**ADDENDUM
NO. 1**

October 28, 2022

**LIBERTY ELEMENTARY SCHOOL RENOVATIONS
Chesterton, IN 46304**

This Addendum consists of Pages ADD 1-1 and attached Addendum No. 1 from Gibraltar Design dated October 26, 2022 and consisting of 4 pages, Hardware Set 17, and 23 Drawings.

A-101

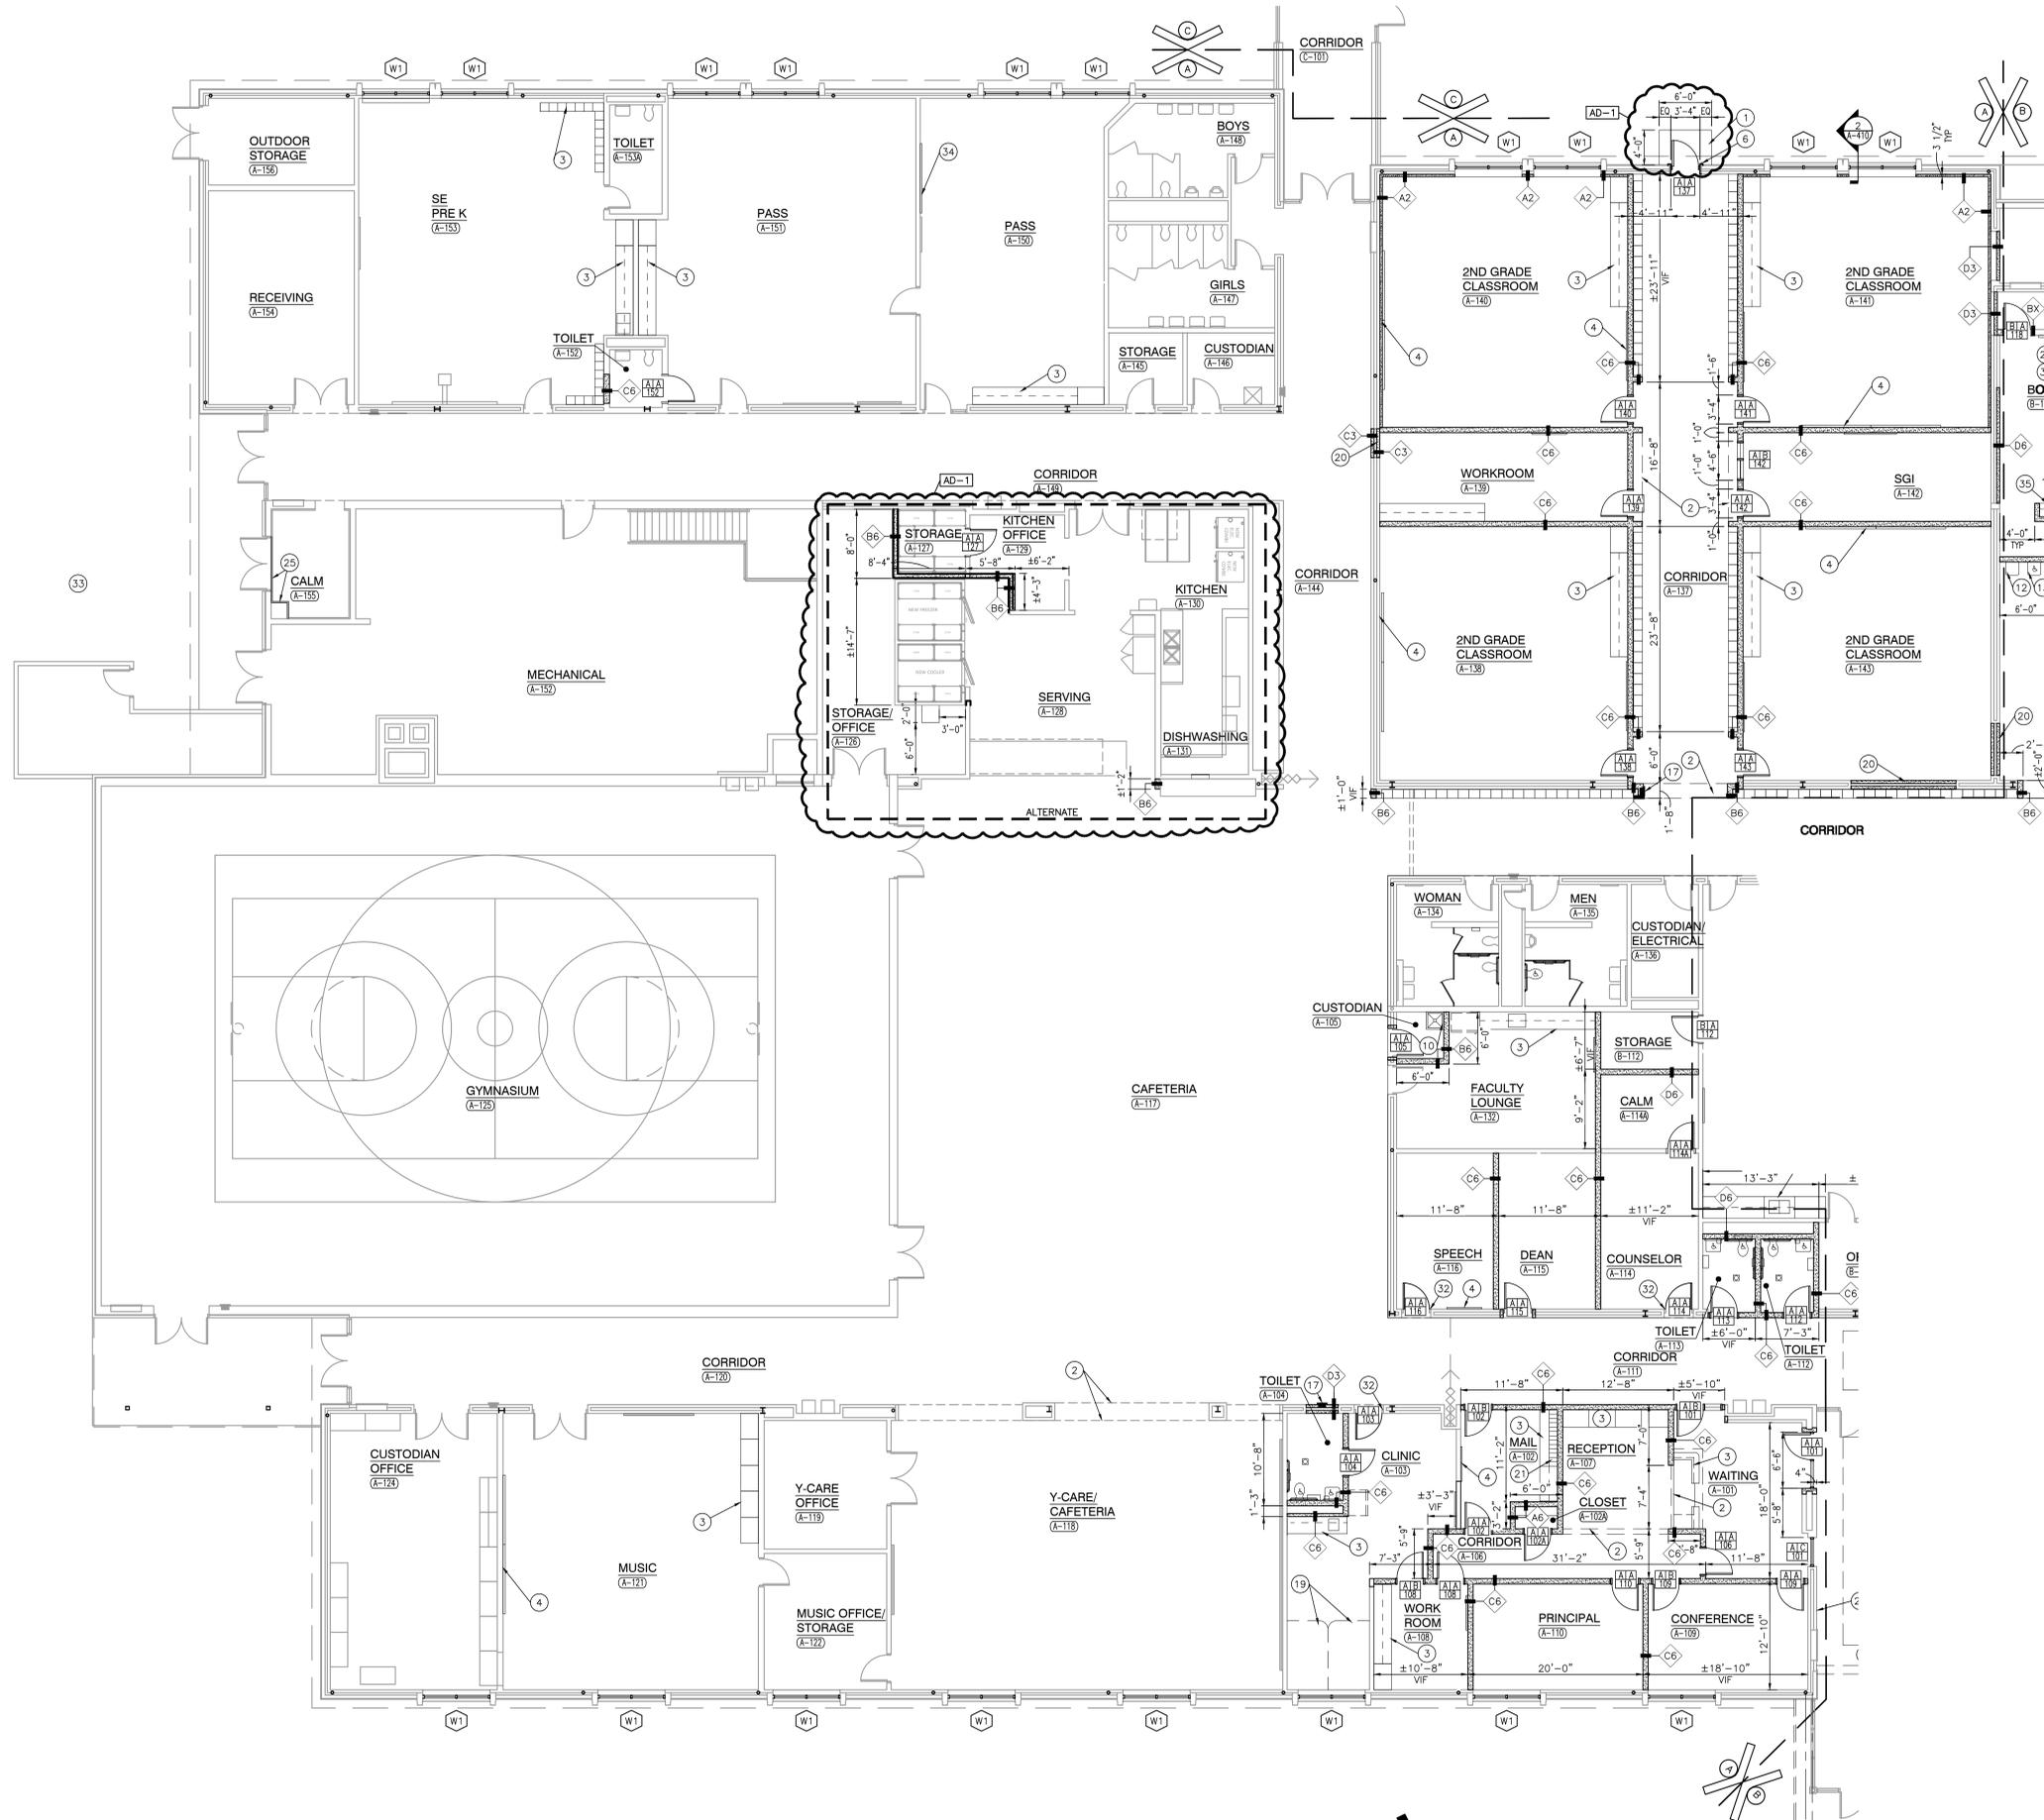
3. Sheet A-101

- A. Refer to revised full size drawings, included in this Addendum, for the following revisions:
 - 1. Updated kitchen layout and alternate designation bubble.
 - 2. Revised Plan Note 1 for void slab structural coordination.
 - 3. Add dimensions to void slab outside door A-137A.

A-102

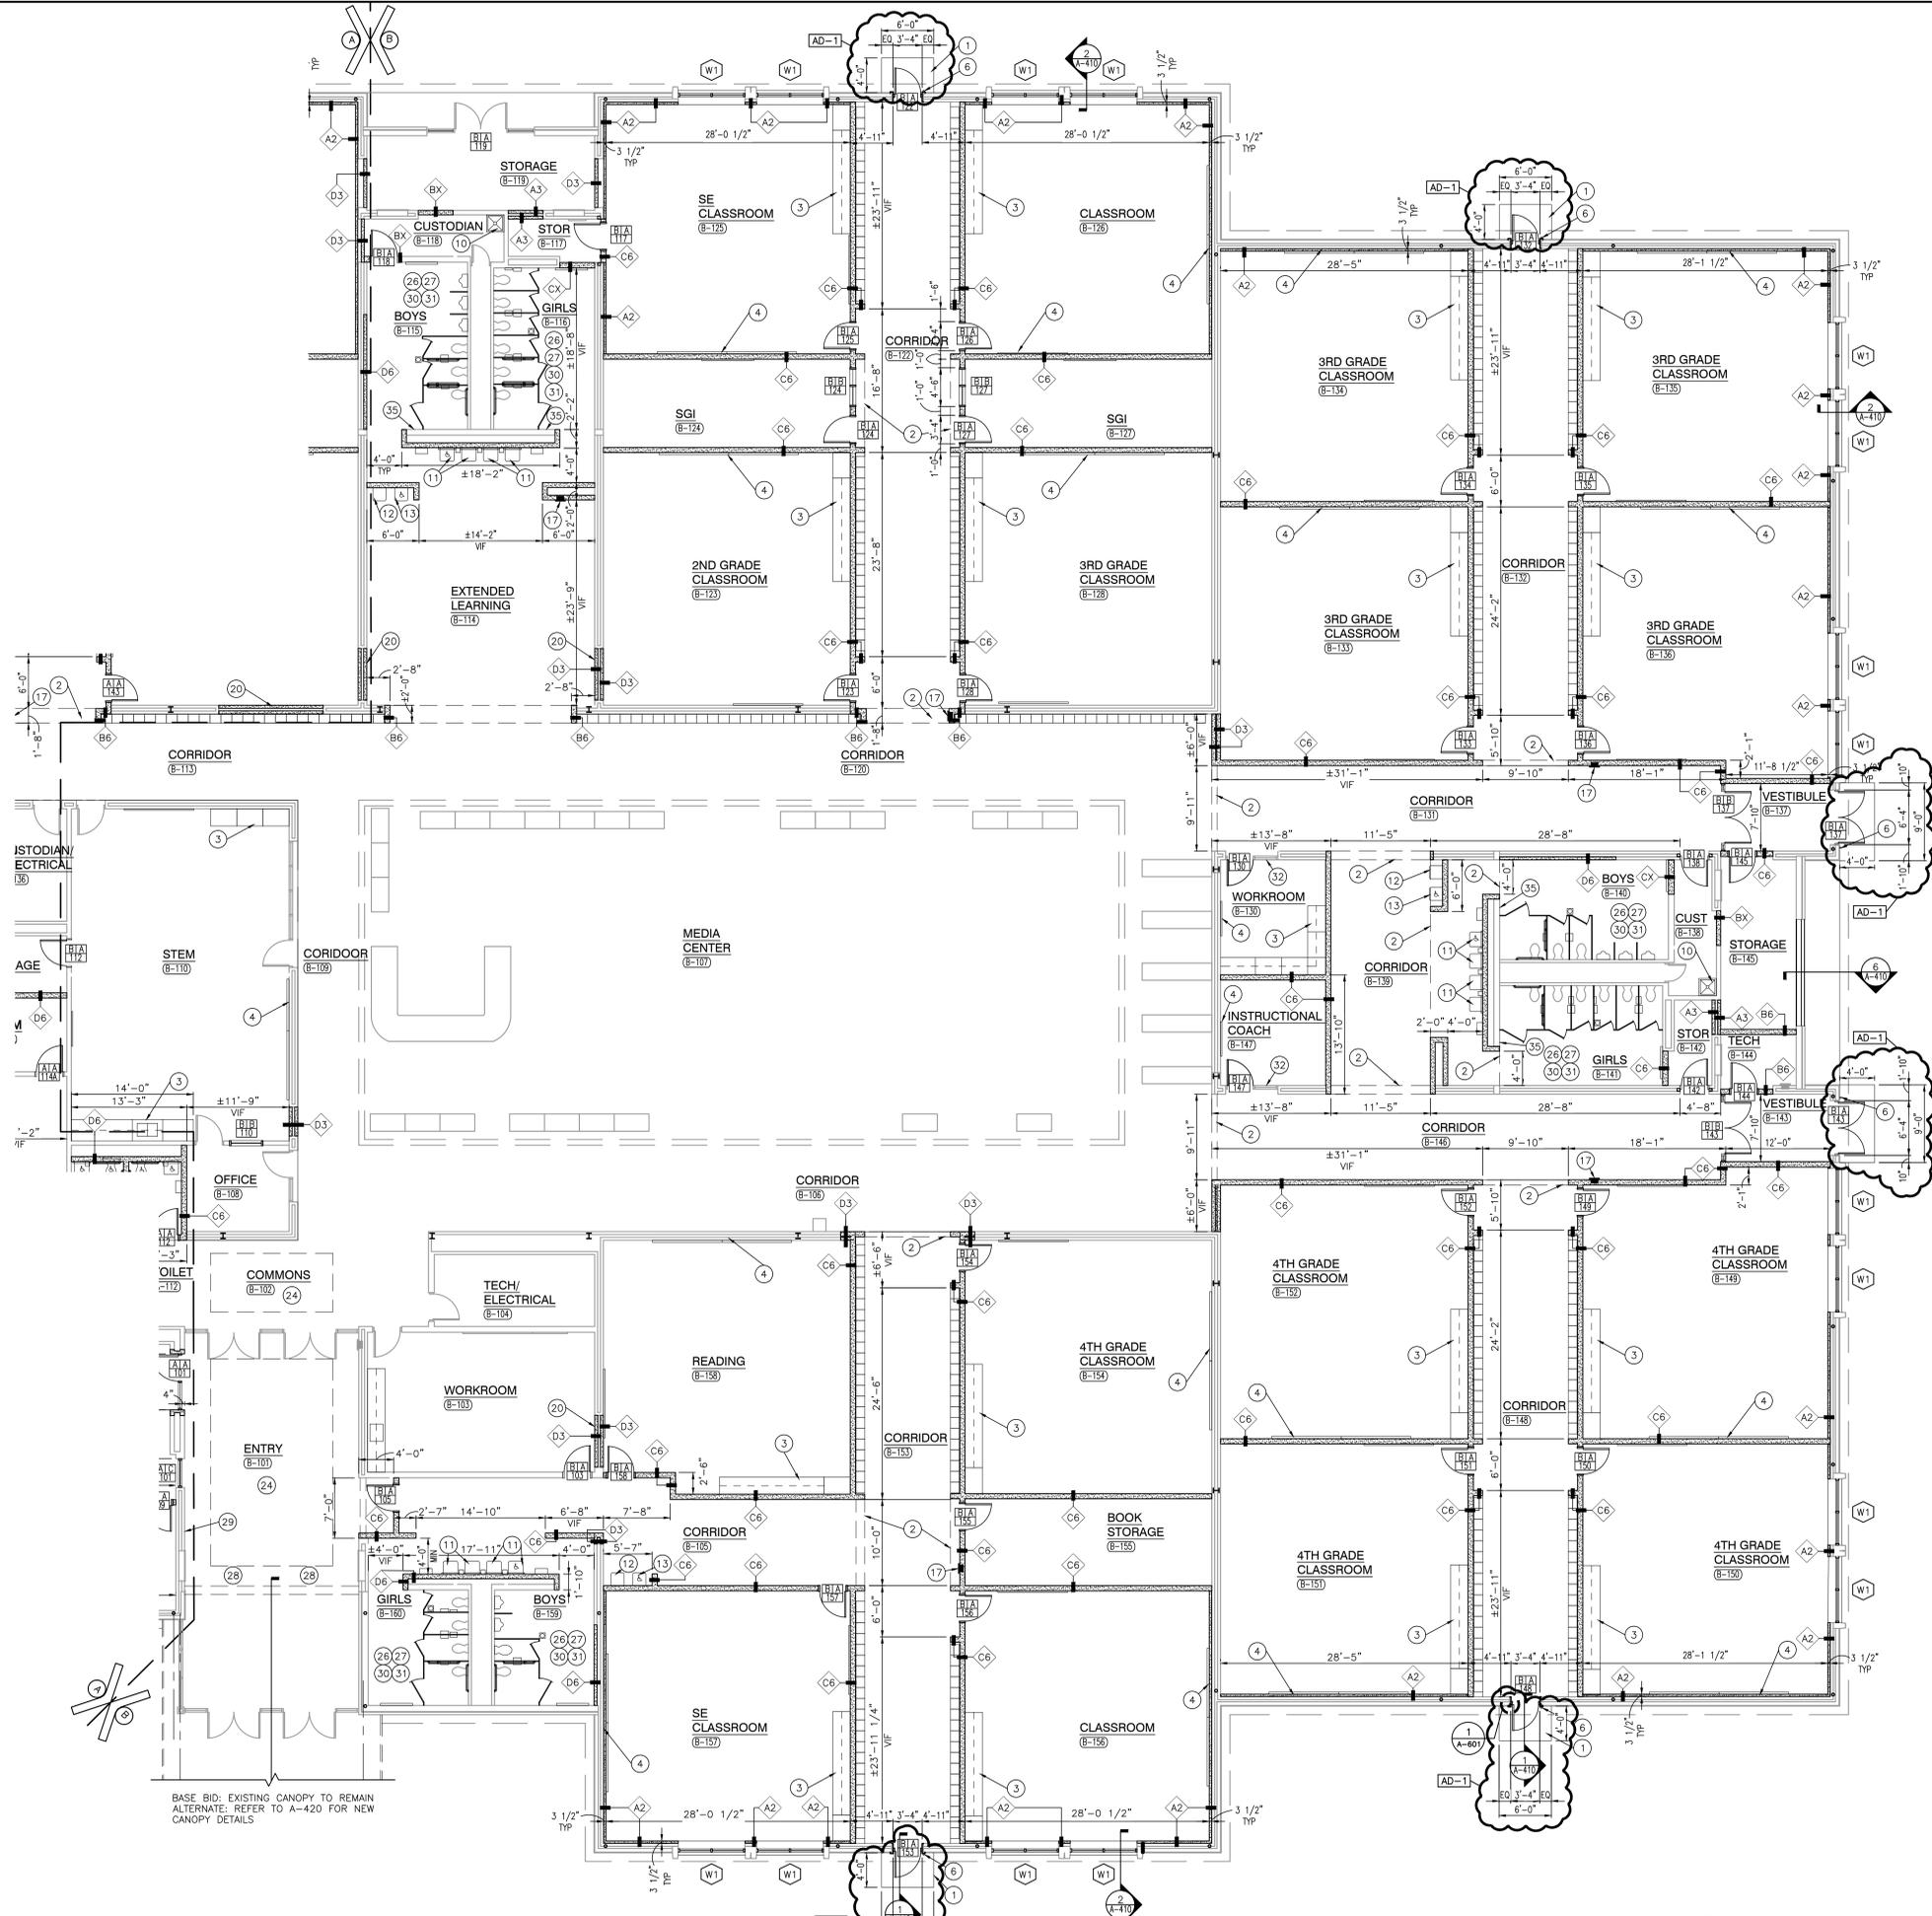
4. Sheet A-102

- A. Refer to revised full size drawings, included in this Addendum, for the following revisions:
1. Revised Plan Note 1 for void slab structural coordination.
 2. Add dimensions to void slab outside doors B-122A, B-132A, B-137A, B-143A, B-148A, B-153A.

© GIBRALTAR DESIGN SHEET
A-103

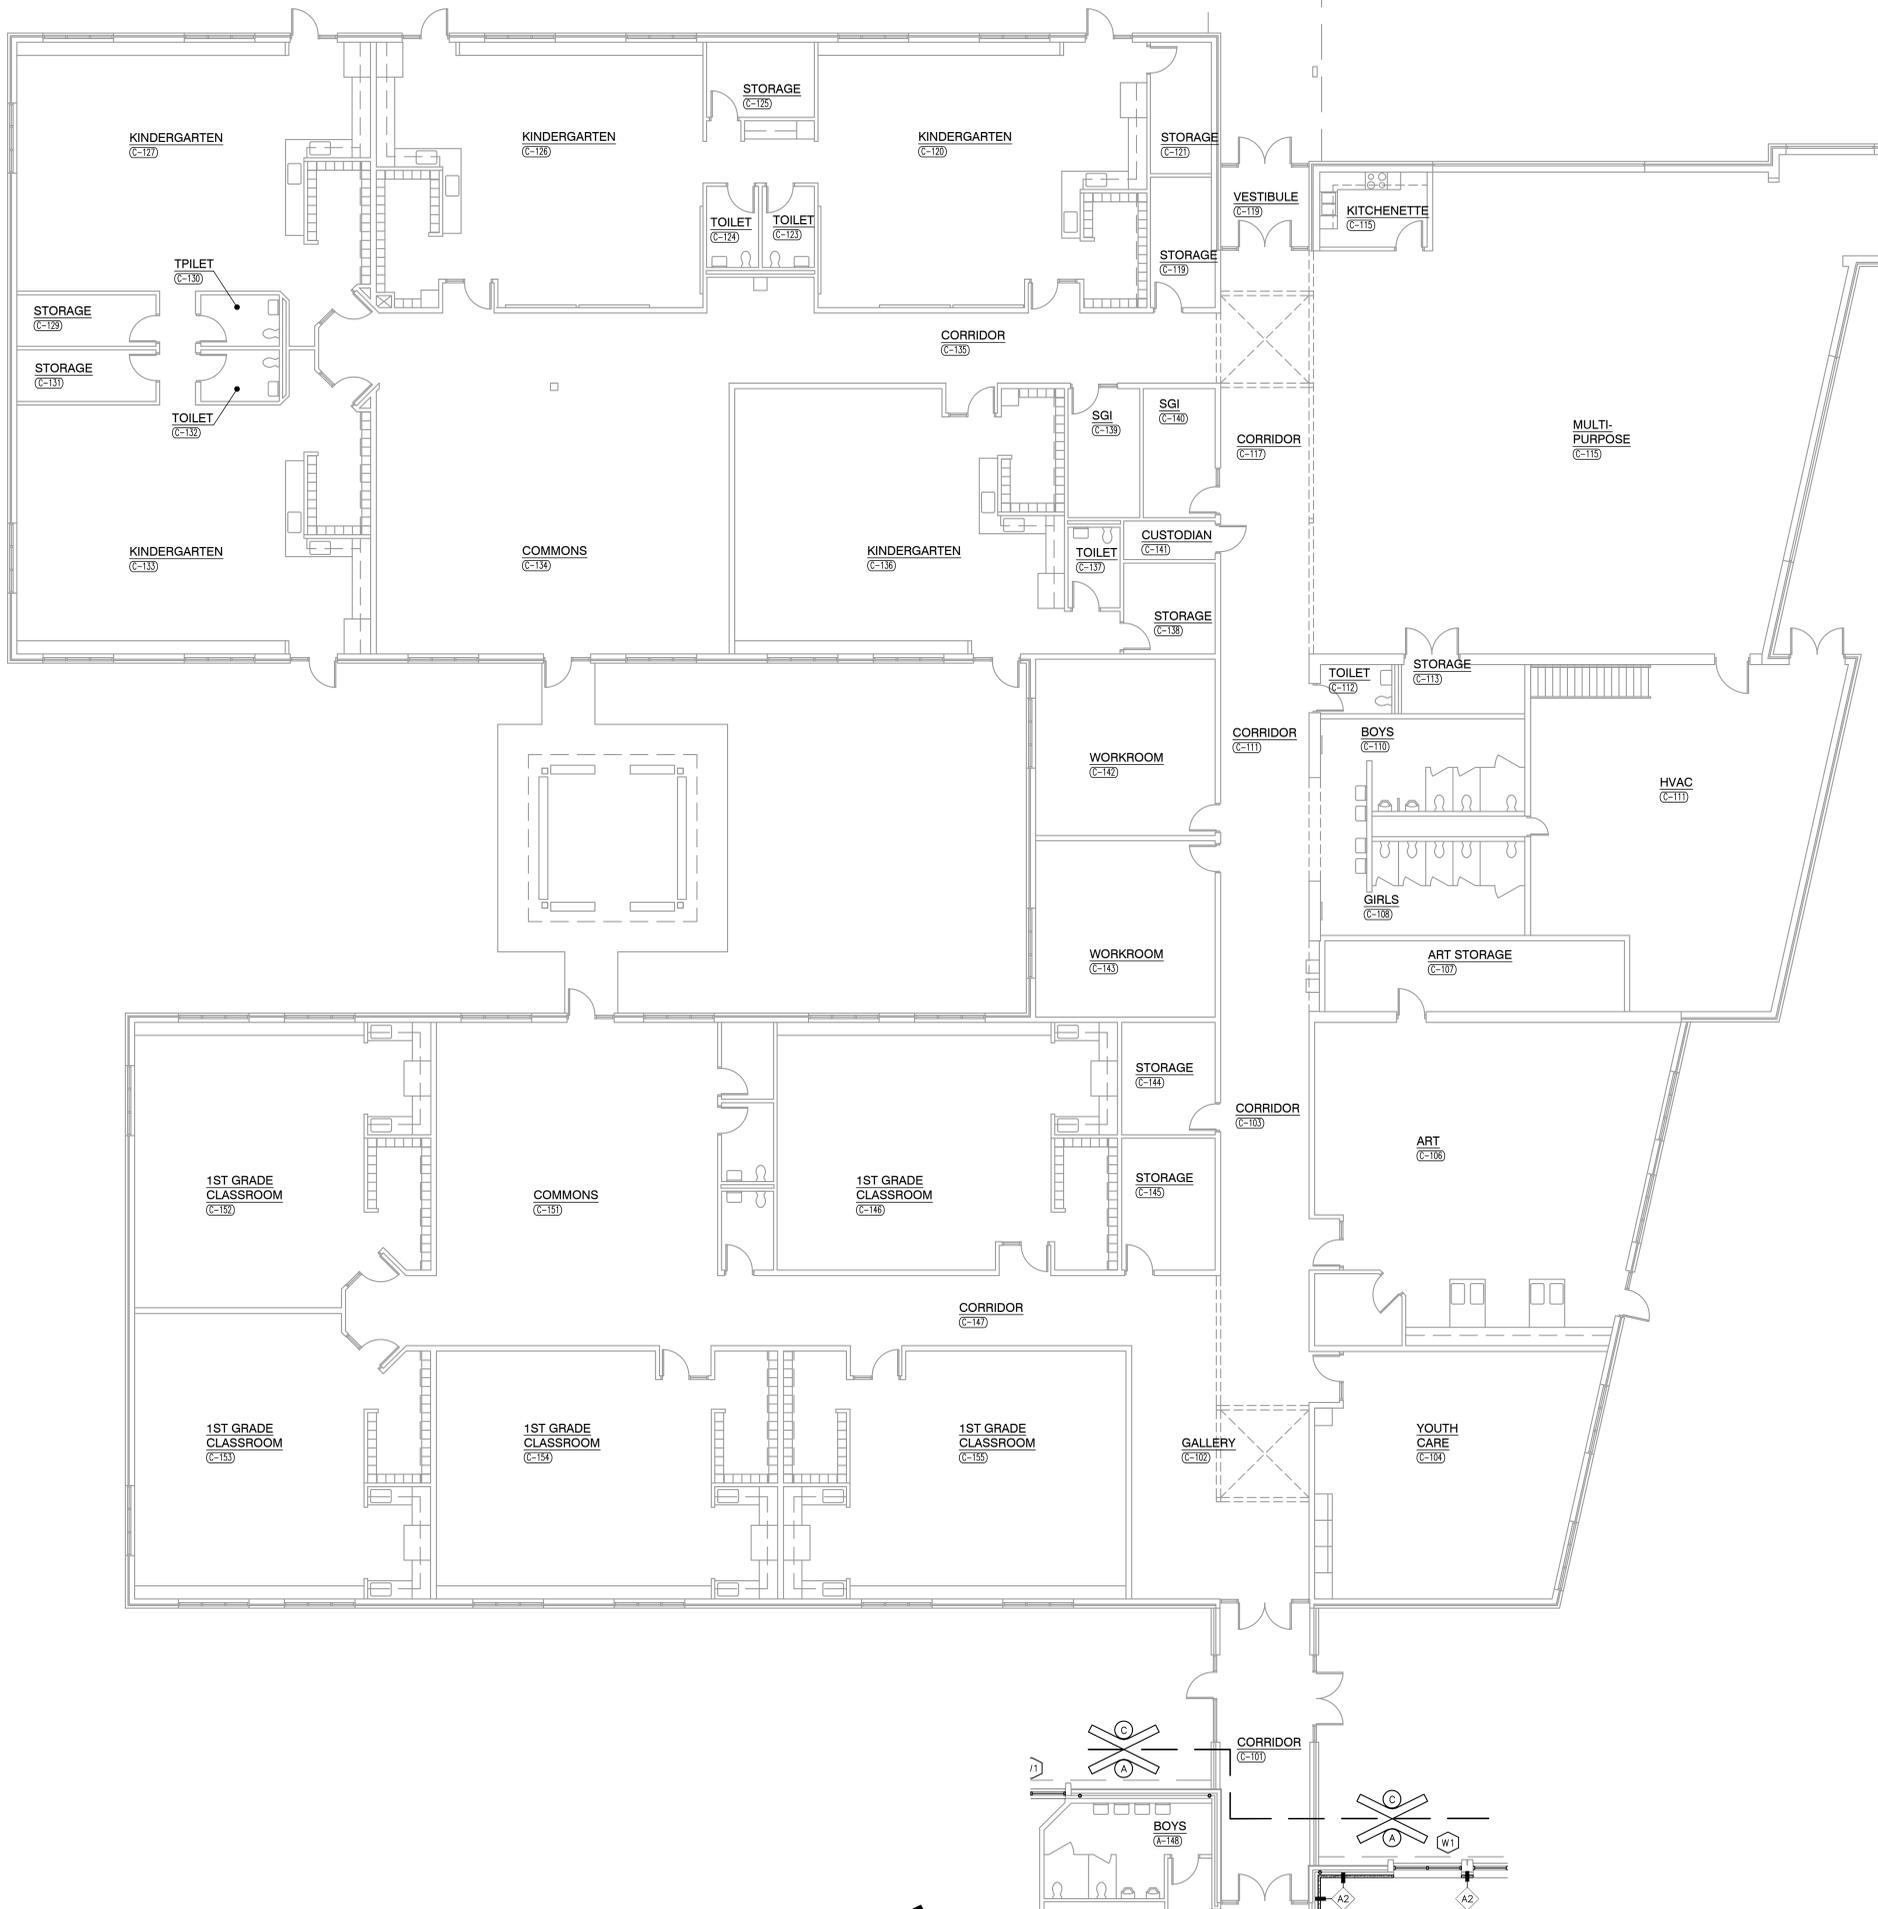
5. Sheet A-103

- A. Refer to revised full size drawings, included in this Addendum, for the following revisions:
1. Revised Plan Note 1 for void slab structural coordination.
